## **AUGUSTA SUBDIVISION, UNIT SEVEN**

***Revised for the June 7<sup>th</sup> Meeting***

APPLICATION NUMBER 1 DATE June 7, 2007

# DETAIL SITE PLAN

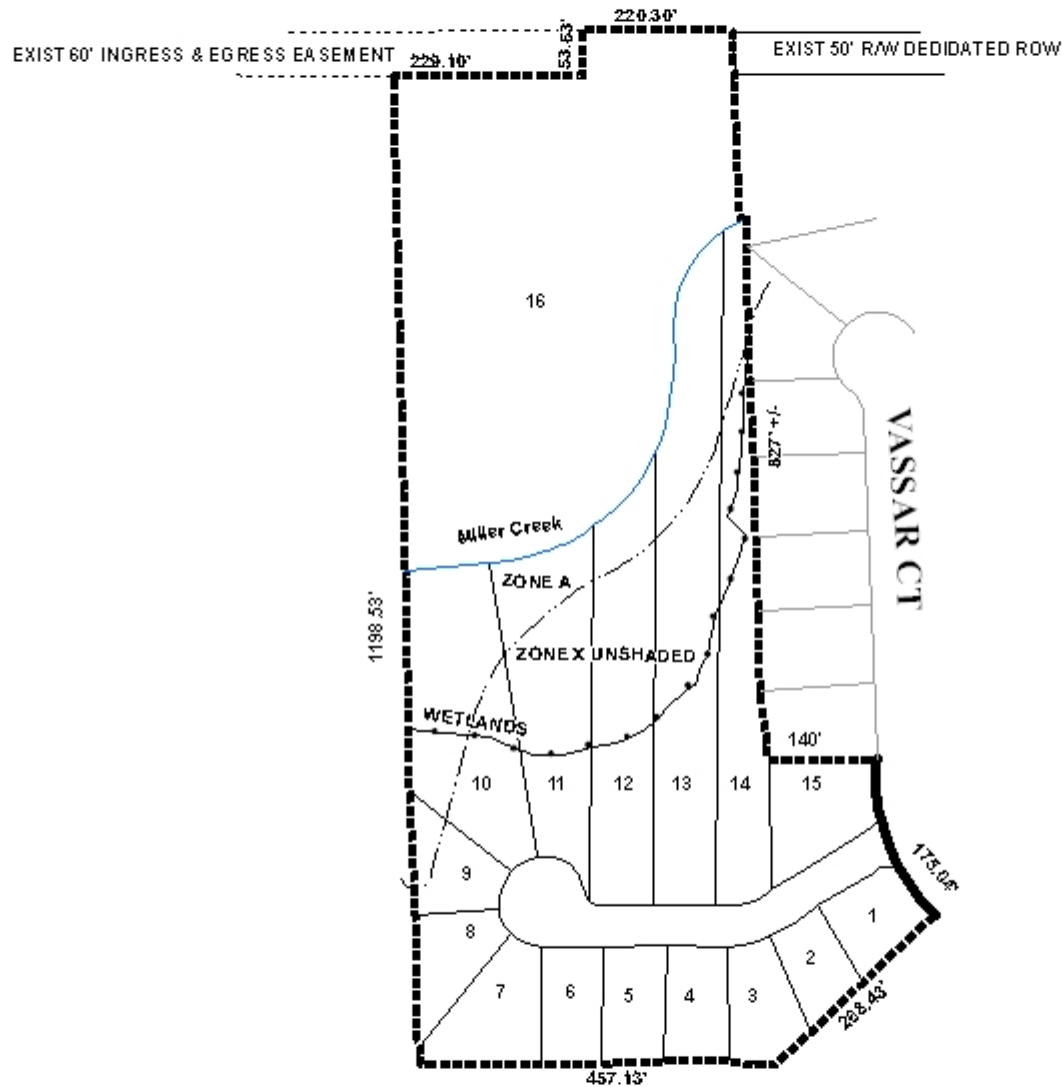
As illustrated on the preliminary plat, a cul-de-sac is proposed from Vassar Court, an existing public road that adjoins the proposed site. The proposed subdivision will incorporate three existing lots (18, 19, & 20) of Augusta Subdivision, Unit Six to provide access to the new street.

The new road for the site is to be dedicated and constructed to meet County Engineering Standards. Additionally, since Lots 1 and 15 are corner lots, a note should be placed on the Final Plat stating that Lots 1 and 15 are limited to one curb-cut each with the size, design and located to be determined by County Engineering.

Lots 11-14 as proposed exceed the depth to width ratio recommended by Section V.D.3. of the Subdivision Regulations. It should also be pointed out that lots exceeding the recommended depth to width ratio are common along creeks, wetlands and tributaries, thus a waiver of Section V.D.3. may be appropriate.

It appears that each lot meets the minimum size requirements for developments with access to public water and sewer. Due to the size of the proposed development, it is requested that the applicant revise the preliminary plat to provide the size of each lot in square feet on the plat, either as a table or as a label for each individual lot.

The 25-foot minimum building setback lines, required in Section V.D.9., are not shown, but would be required on the final plat.

The plat contains only a portion of the overall metes and bounds parcel. Therefore, the application should be heldover to allow inclusion of the remainder of the parcel, or to allow for submission of documentation to establish included portion of the metes and bounds parcel as a lot parcel of record prior to 1984.

*The applicant has submitted a revised plat; however, it does not include the entire remaining parcel as Lot 16. However, Lot 16 as proposed would front Grelot Road Extension, a proposed major street; therefore, the dedication of 50-feet from the centerline of the proposed Grelot Road Extension to provide half of the required 100-feet of right-of-way required for the major street would be required. Additionally, Lot 16 should be relabeled "Future Development" due to the inaccessible access from a county approved and maintained right-of-way.*

*Lots 10-14 as proposed exceed the depth to width ratio recommended by Section V.D.3. of the Subdivision Regulations. It should also be pointed out that lots exceeding the recommended depth to width ratio are common along creeks, wetlands and tributaries, thus a waiver of Section V.D.3. may be appropriate.*

*With a waiver of Section V.D.3 of the Subdivision Regulations, the plat meets the minimum requirements of the Regulations and is recommended for Tentative Approval subject to the following conditions:*

- 1) the inclusion of the remaining portion of parcel R022707350000030.005 prior to the signing off the Final Plat;*
- 2) the labeling of Lot 16 as "Future Development" on the Final Plat;*

- 3) *the new roads within the proposed subdivision be dedicated and constructed to County Engineering standards;*
- 4) *the placement of a note on the Final Plat stating that Lots 1 & 15, which are corner lots are limited to one curb cut, with the size, design and location to be determined by County Engineering;*

- 7) *labeling of the lots with its size in square feet, or provision of a table on the plat with the same information;*
- 8) *the approval of all applicable federal, state and local agencies would be required prior to the issuance of any permits or land disturbance activities; and*

- 9) *the depiction of the 25-foot minimum building setback lines the new streets.*
